DATE: April 9, 2009

Addenda No. 2

SUBJECT: US20: Bulger Cr – Riley Jct. Section
Central Oregon Highway
Harney County
Paving Project
(Bids to be opened and read April 16, 2009)

FEDERAL HIGHWAY ADMINISTRATION	PROJECT NUMBER	SHEET NO.
OREGON DIVISION	X-NH-S007(051)	1

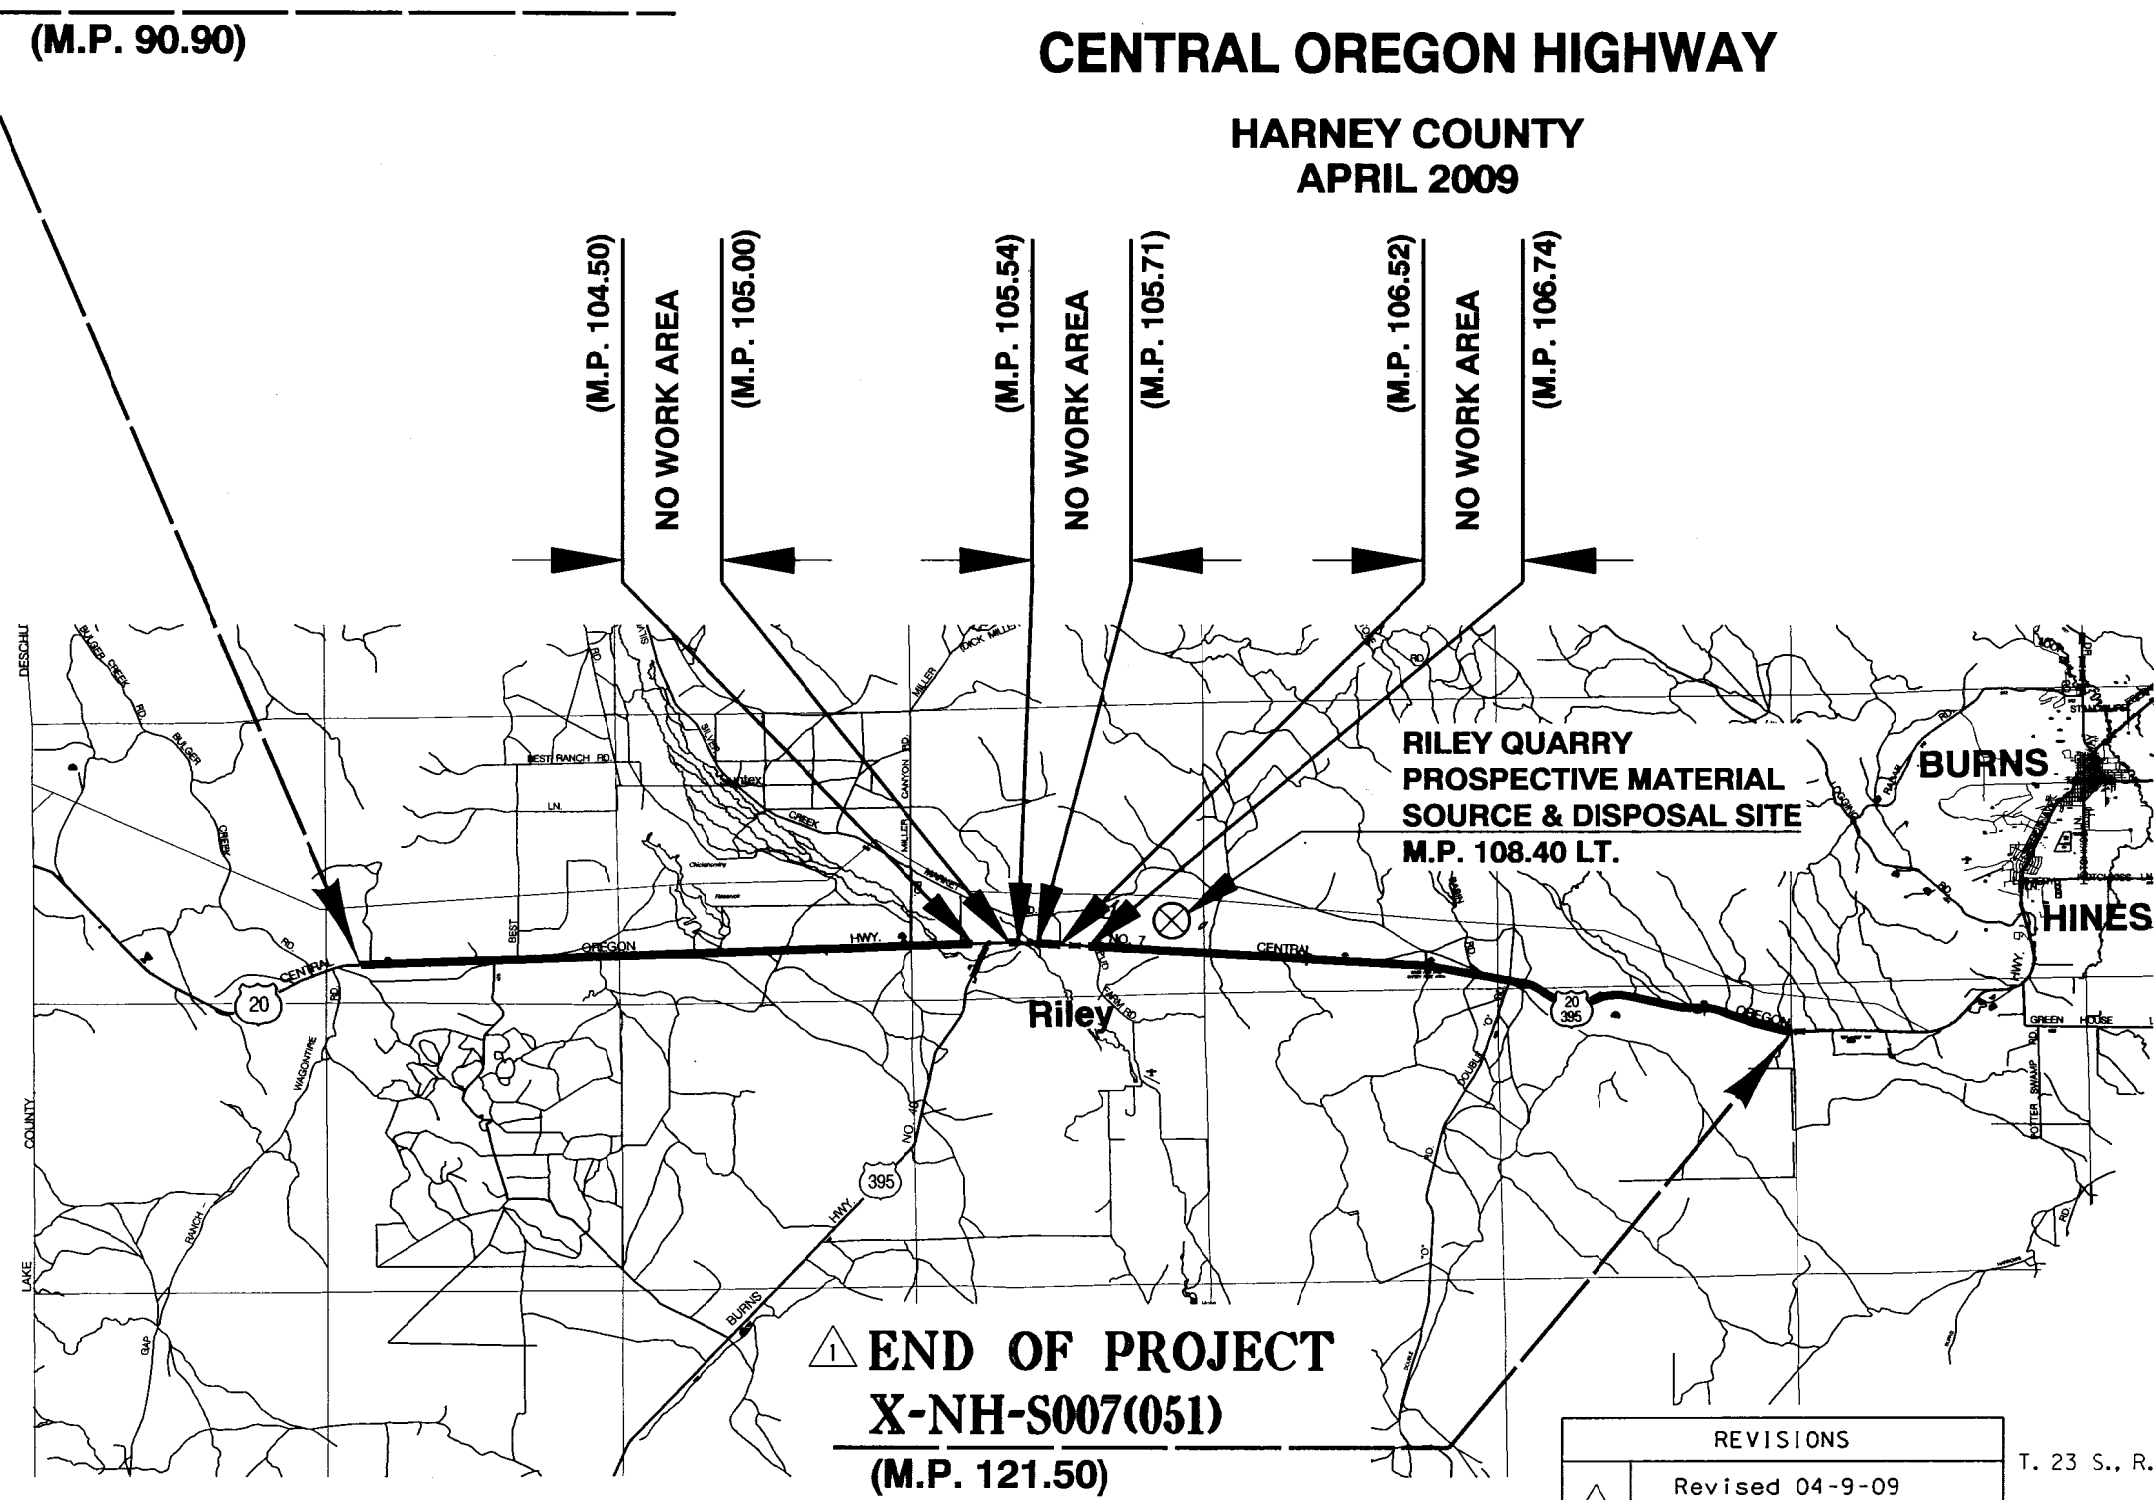
REVISIONS	
1	Revised 04-9-09 Revised End of Project Location

TYPICAL SECTIONS	SHEET NO. 2
-------------------------	-----------------------

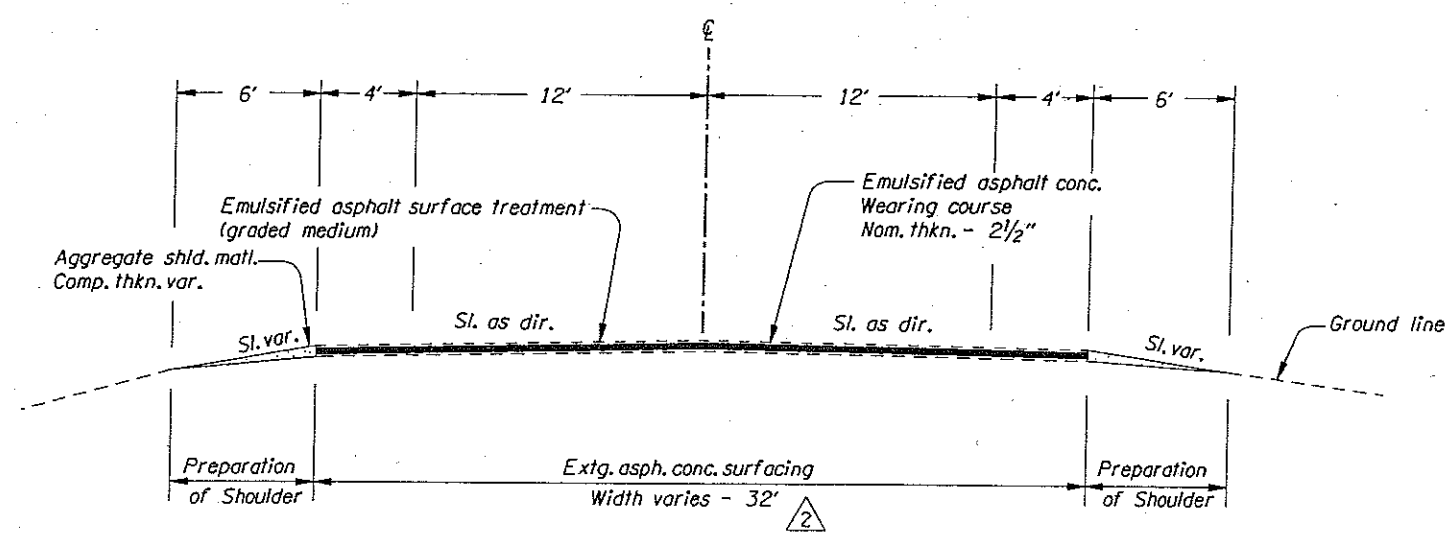
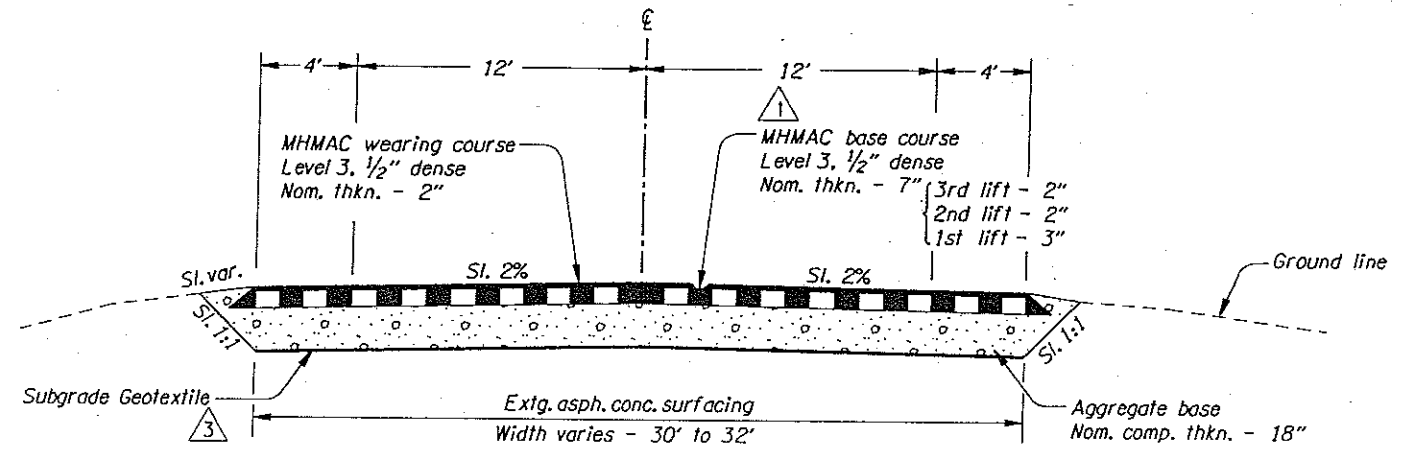
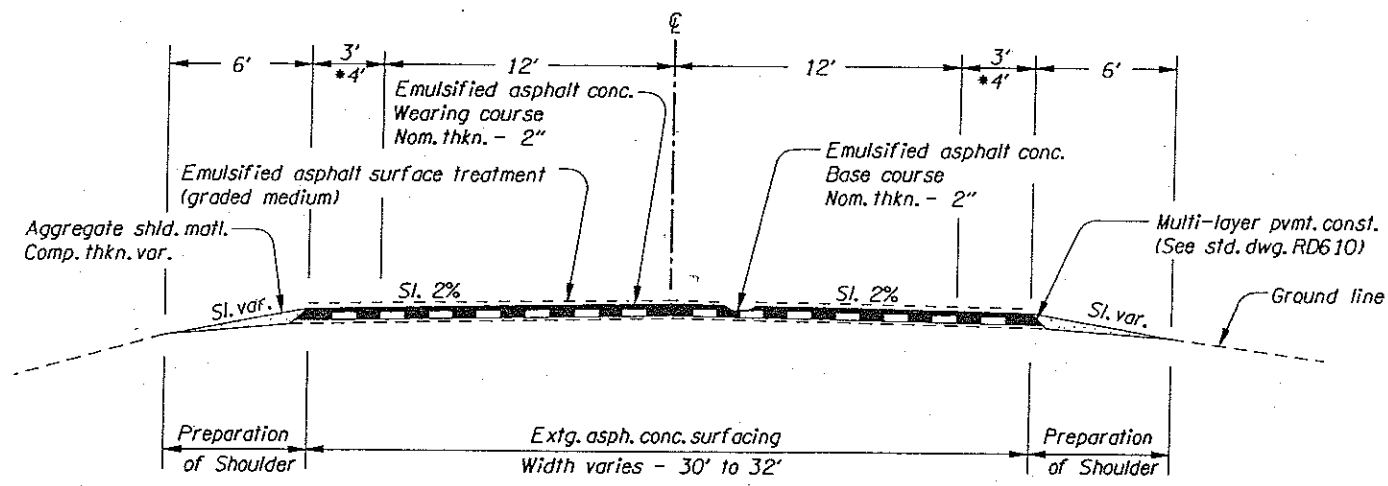
REVISIONS	
△1	4/9/2009 Change Level 2 to Level 3
△2	4/9/2009 Change extg. pvmt. width
△3	4/9/2009 Added Subgrade Geotextile

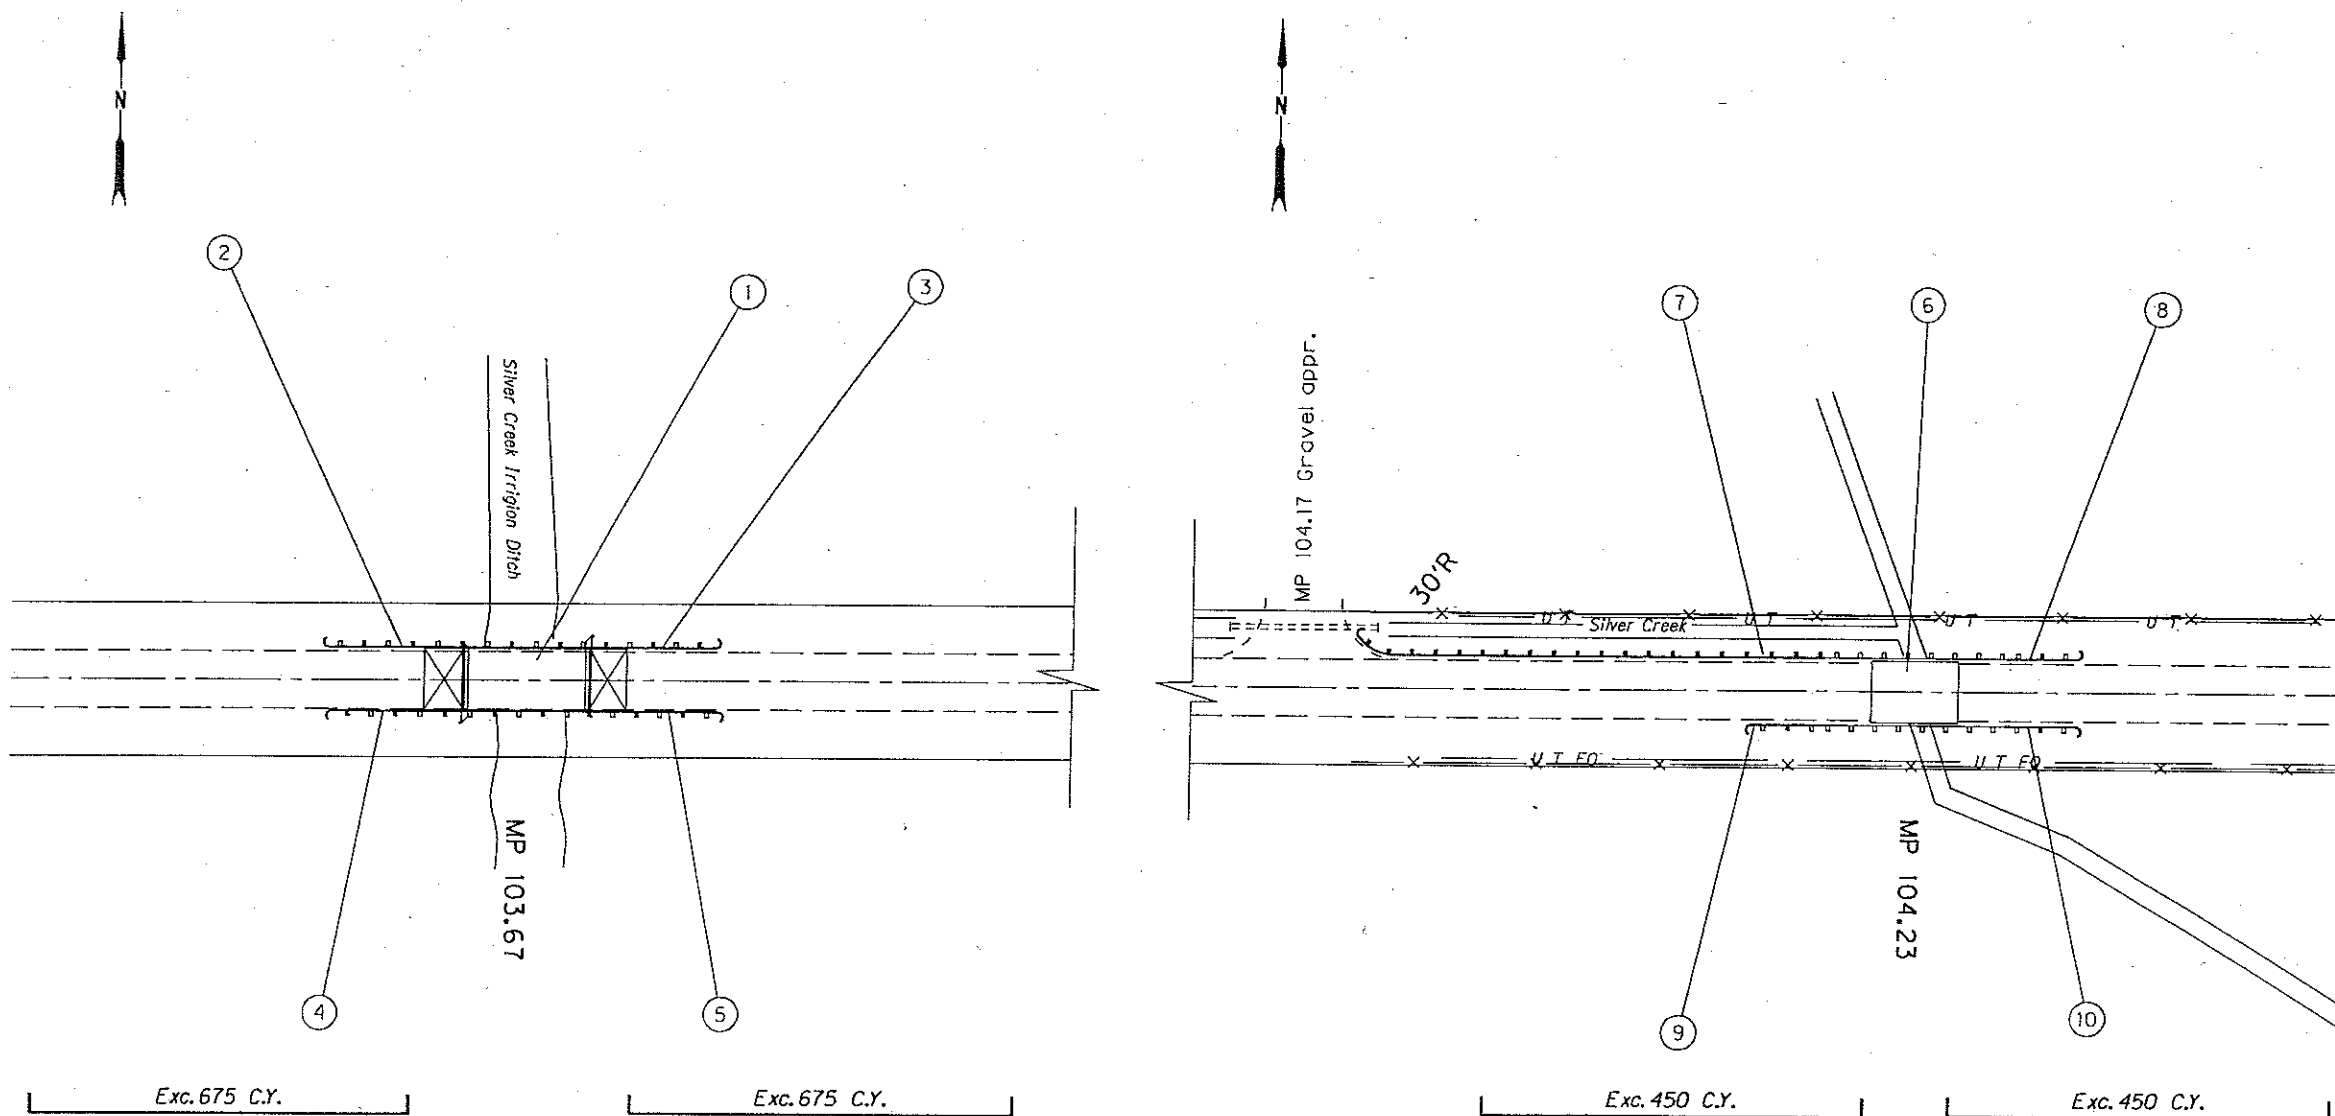
- ⑦ Remove extg. guardrail - 37.5'
Const. guardrail 250' (Type 2A)
E=1'
Const. anchor - 2 (Type 1 Mod.)
Install end piece, Type B
(See drg. no RD450)
(For details, see sht. 2B-2) ⚠

- ⑧ Remove extg. guardrail - 37.5'
Const. guardrail terminal, non-flared
W=1', E=1'
(For details, see sht. 2B-2) ⚠
- ⑨ Remove extg. guardrail - 37.5'
Const. guardrail terminal, non-flared
W=1', E=1'
(For details, see sht. 2B-2) ⚠

- ⑩ Remove extg. guardrail - 37.5'
Const. guardrail terminal, non-flared
W=1', E=1'
(For details, see sht. 2B-2) ⚠

REVISIONS	
⚠	4/9/2009 Modified construction note

SHEET NO. 2B

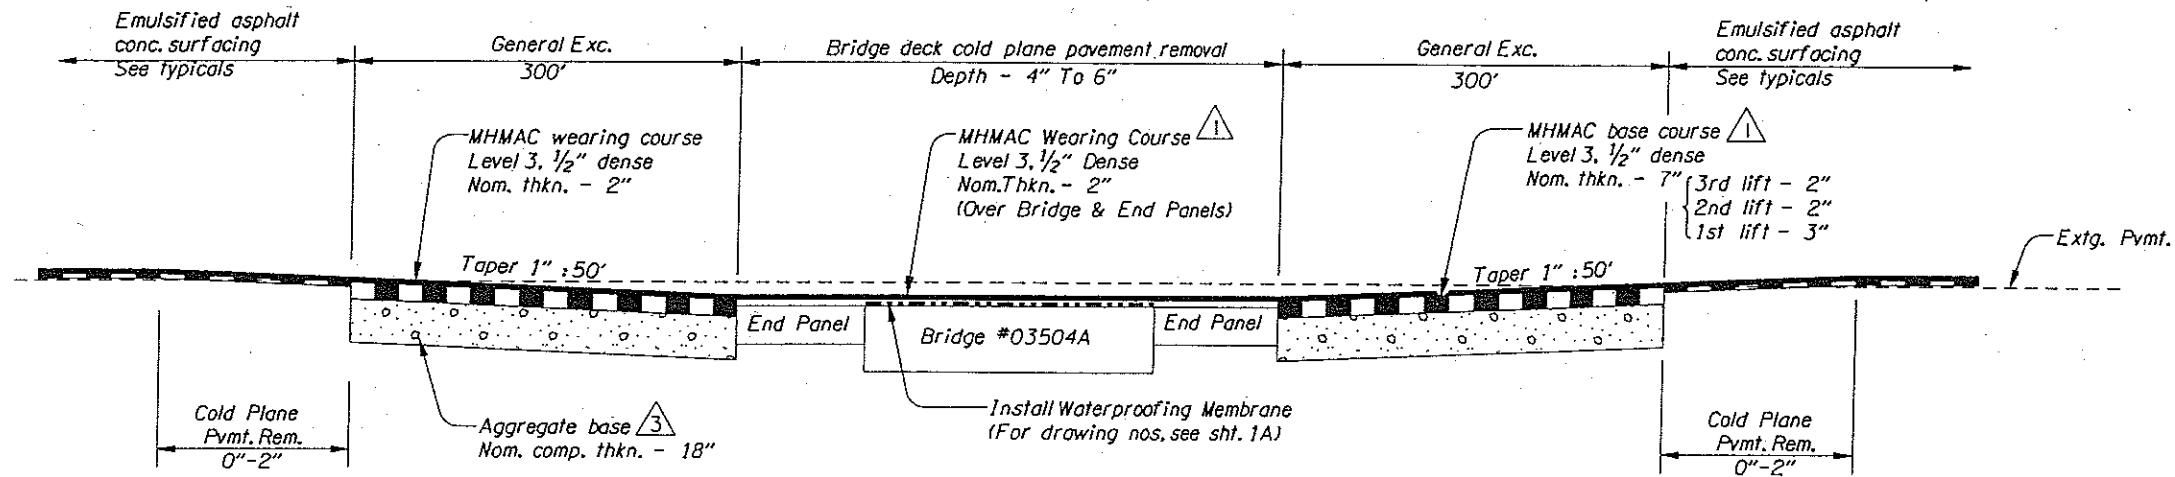
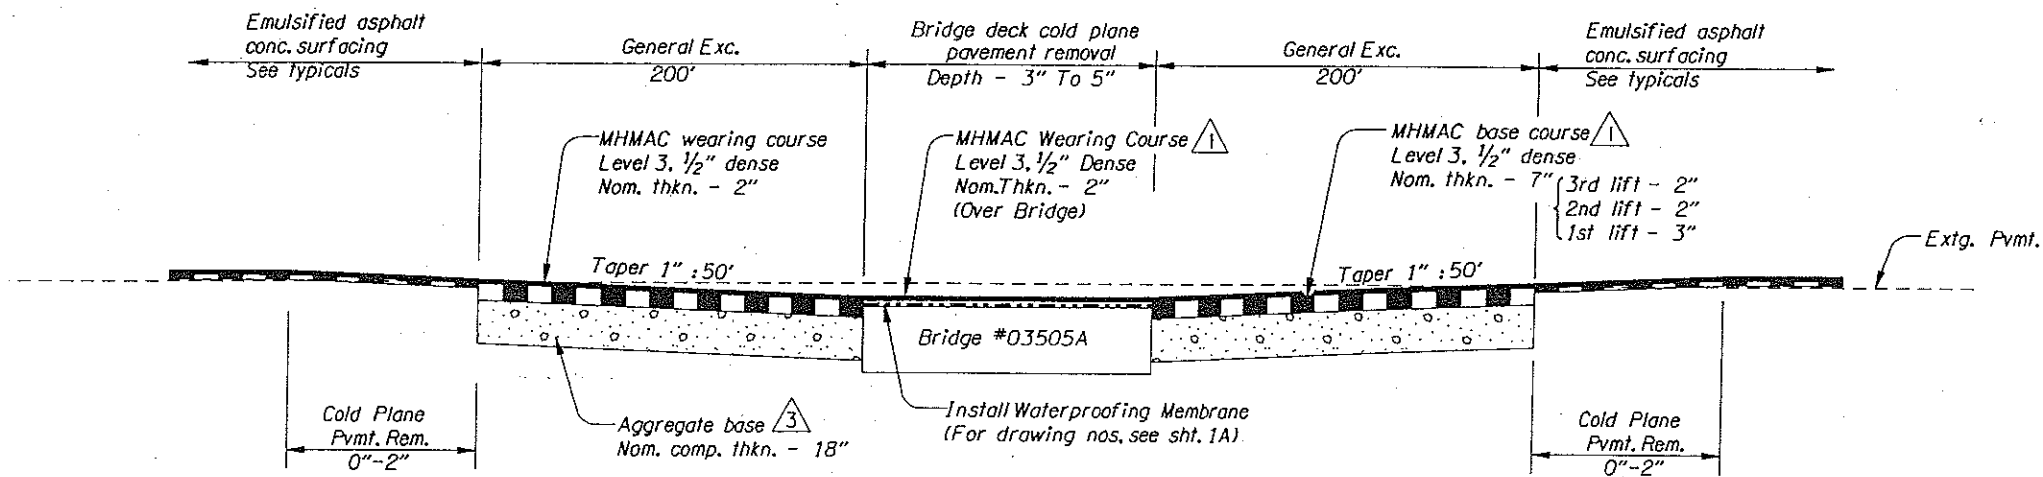
REVISIONS	
1	4/9/2009 Change Level 2 to Level 3
2	4/9/2009 Change sheet no. from 2A to 2B
3	4/9/2009 Added depth of base rock
